Illustrated Parts List - IPL Update

T540XP II

IPL updates

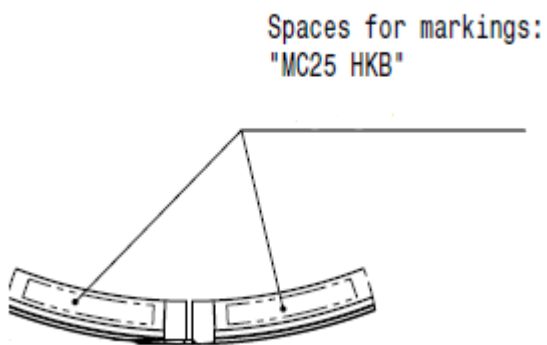
1. A new Piston assy 586 44 62-04 and Piston ring 593 64 49-01 have been introduced. The change has been made to improve engine durability and start ability.
2. New article number for Cylinder assy due to new Piston assy.
3. Old Piston ring 577 96 05-01 will remain as spare part for Piston 586 44 62-02.

This update is fully exchangeable regarding Cylinder assy and Piston assy. Piston ring is **not** exchangeable.

Page Title	Ref . no	New part no	Name	Excl. part no.	Remark
Cylinder & Piston	1	586 34 15-02	Cylinder assy	576 67 62-02	
	2	586 44 62-04	Piston assy	586 44 62-02	
	4	593 64 49-01	Piston ring MC25 HKB		New Spare part.
